Access Compliance Report

Public Rights-of-Way

(Curb Ramps)

Intersection ID: 21161	Main Street: FOLGER_DR	Cross Street: PROVIDENCE_RD	Location: SE
ADA ID: 0F8553E8EE09	Ramp Type: Perp	Initial Pass/Fail: Fail	Overall Compliance: No
Codes/Mitigation Info/Possible Solution			Severity Score: 25
			Field Measurements/Component Compliance

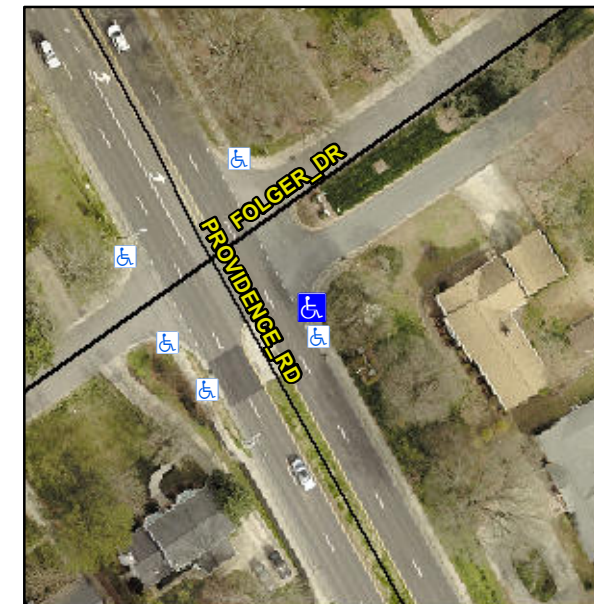
Not Found, R304.2.2

Compliance	Description	Data	Compliance	Description	Data
N/A	Ramp Length (in)	61.0	No	Ramp Slope (%)	12.7
Yes	Ramp Width (in)	48.0	Yes	Ramp XSlope (%)	1.3
N/A	Flare Type LT	N/A	N/A	Flare Type RT	N/A
N/A	Flare Slope LT (%)	N/A	N/A	Flare Slope RT (%)	N/A
N/A	Flare Traversable LT?	N/A	N/A	Flare Traversable RT?	N/A
N/A	Landing Length (in)	N/A	N/A	DWS Provided?	N/A
N/A	Landing Width (in)	N/A	N/A	DWS Contrast?	N/A
N/A	Landing Slope (%)	N/A	N/A	DWS Length (in)	N/A
N/A	Landing X Slope (%)	N/A	N/A	DWS Full Width?	N/A
N/A	Landing Curb? (Y/N)	N/A	N/A	DWS Offset (in)	N/A
N/A	Shared Landing?	N/A			
N/A	Gutter Ponding?	N/A	N/A	Gutter Slope (%)	N/A
N/A	Gutter Lip Ht (in)	N/A	N/A	Gutter X Slope (%)	N/A
N/A	Painted X Walk1?	No	N/A	Painted X Walk2?	N/A
	X Walk 1 Direction	To NW		X Walk 2 Direction	N/A
N/A	X Walk 1 Width (in)	N/A	N/A	X Walk 2 Width (in)	N/A
	X Walk 1 Slope (%)	2.0		X Walk 2 Slope (%)	N/A
	X Walk 1 X Slope (%)	1.1		X Walk 2 X Slope (%)	N/A

Remove & Replace Entire Ramp.
